Re: Indian Point Unit No. 2
Docket No. 50-247
NL-06-020

Subject: Application for a Technical Specification Change to Add Spent Fuel Cask Loading Requirements

**ANALYSIS OF PROPOSED TECHNICAL SPECIFICATION
CHANGES REGARDING THE ADDITION OF SPENT FUEL
CASK LOADING REQUIREMENTS**

**MARKED-UP TECHNICAL SPECIFICATION AND CORRESPONDING
BASES PAGES REGARDING THE ADDITION OF SPENT FUEL CASK
LOADING REQUIREMENTS**

Figure 3.7.16-1
Fuel Assembly Burnup Limit Requirements for Cask Storage

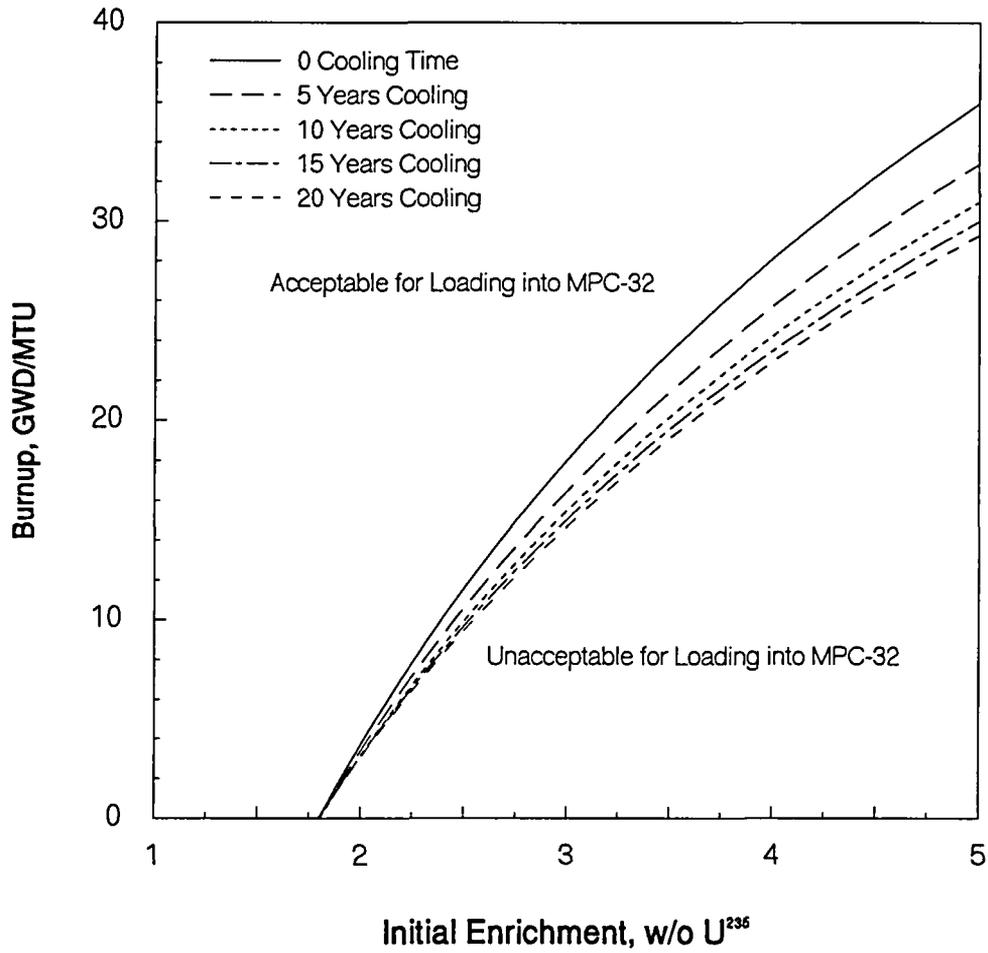
5. A new TS Figure, Figure 3.7.16-1 will be added that specifies acceptable combinations of fuel assembly initial enrichment, burnup and cooling times for MPC-32 cask loading operations.

LCO 3.7.16 The combination of initial enrichment and burnup of each spent fuel assembly stored in the cask storage area shall be within the acceptable burnup domain of Figure 3.7.16-1.

- 4.3.1.3 The spent fuel casks are designed and shall be maintained with:
- a. Fuel assemblies having a maximum U-235 enrichment of 5.0 weight percent;
 - b. $k_{\text{eff}} < 1.0$ if fully flooded with unborated water;
 - c. $k_{\text{eff}} \leq 0.95$ if fully flooded with water borated to 250 ppm;
 - d. A nominal 9.218 inch center to center distance between fuel assemblies placed in the spent fuel cask; and
 - e. Spent fuel assemblies with a combination of discharge burnup and initial enrichment in the acceptable burnup domain of Figure 3.7.16-1.
